UNITED STATES PATENT AND TRADEMARK OFFICE

APPLICATION NO.	FILING DATE	FIRST NAMED INVENTOR	ATTORNEY DOCKET NO.	CONFIRMATION NO.
10/646,008	08/22/2003	Sung-Jae Moon	YOM-0048	8963
7590		03/06/2006	EXAMINER	
Cantor Colburn LLP		NGUYEN, HOAN C		
55 Griffin Road South		ART UNIT		
Bloomfield, CT 06002		PAPER NUMBER		
		2871

Office Action Summary

DETAILED ACTION

Attachment 1
(please scan and mail)

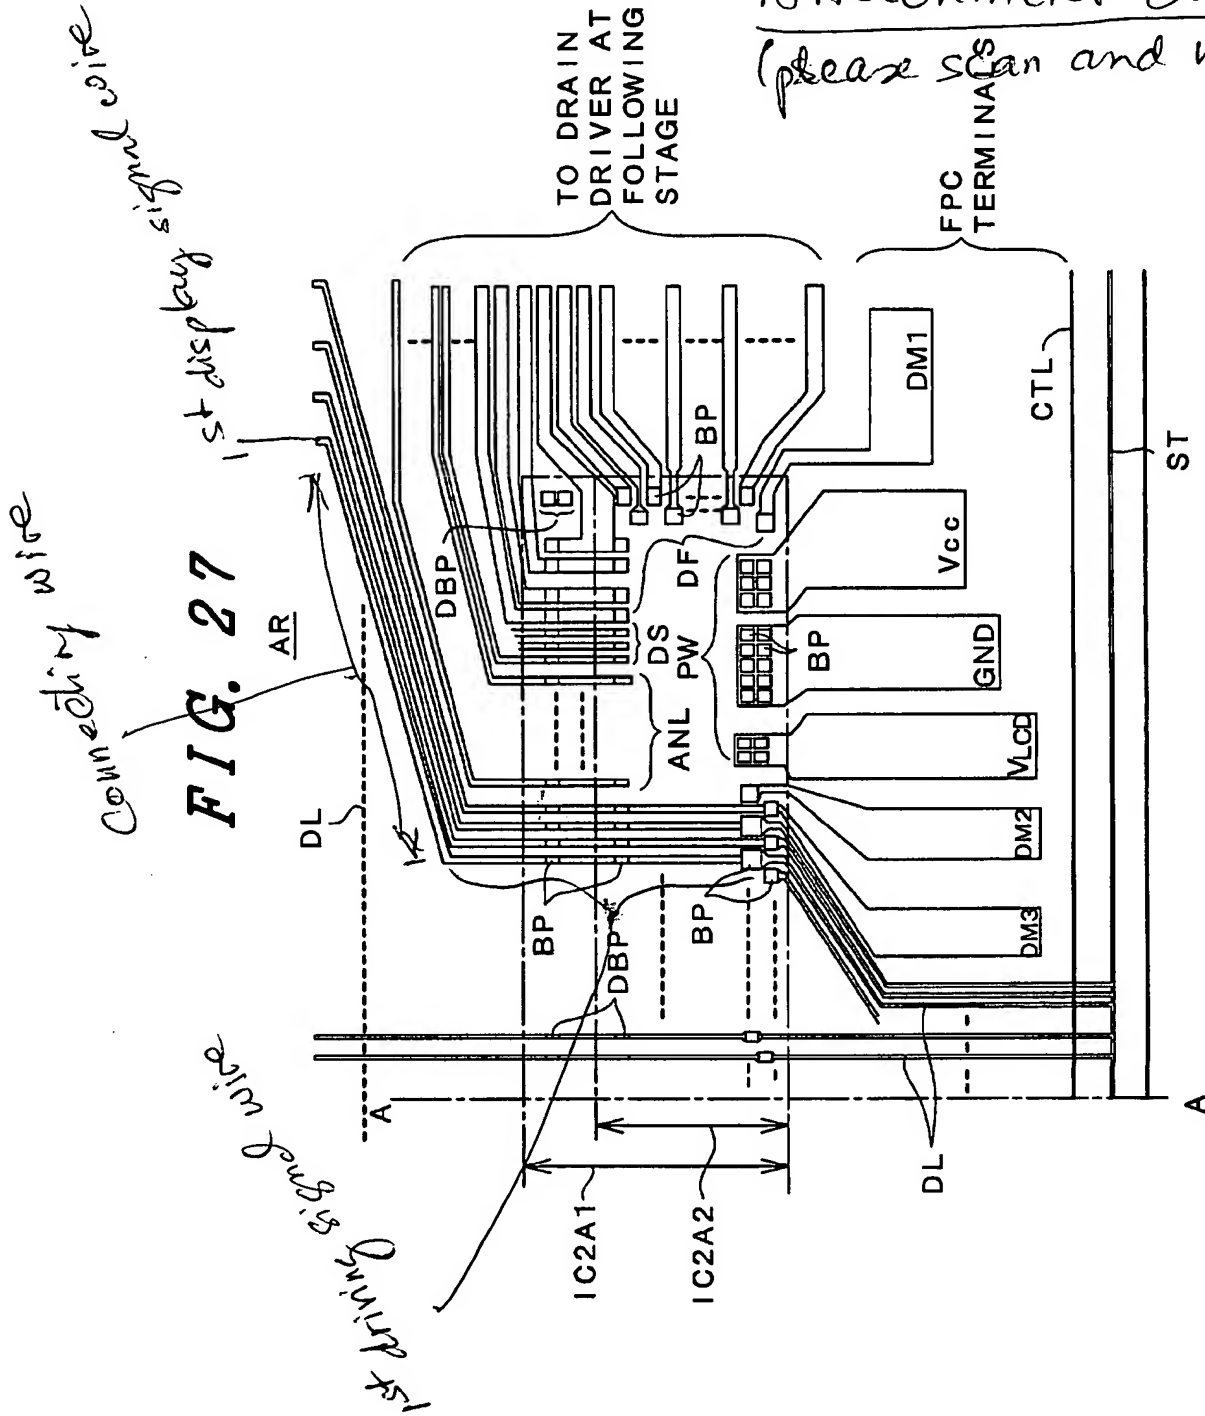
Imajo disclose (Figs. 26-27) "a plurality of first connecting lines disposed between the first driving signal wires and a part of the of first display signal wire (drain lines DL), and connected to at least one of the first driving signal wire and the part of first display signal wire" (see attachments 1-2); or Imajo disclose (Fig. 28) "a plurality of first connecting lines (drain lines outside of SUB2 that is placed on SUB1) disposed between the first driving signal wires (OUT) and a part of the of first display signal wire (drain lines DL inside of SUB2 that is placed on SUB1), and connected to at least one of the first driving signal wire and the part of first display signal wire" (see attachment 3)

FIG. 28 (please scan and mail)

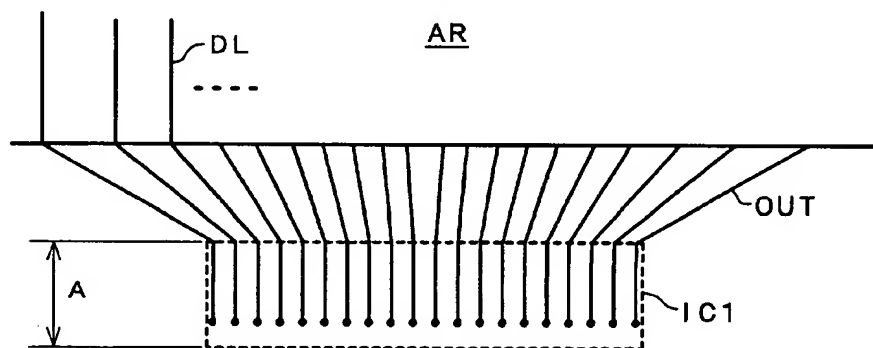
- a plurality of first connecting lines (the wirings OUT in Figs 28 consider as first connecting lines on drain lines side, this lines also show in Fig. 34, see attachment) disposed between the first driving signal wire (data lines DDL and power supply lines PWL-D) and a part of the first display signal wire DL, and connected to at least one of the first driving signal wire and the part of the first display signal wire.
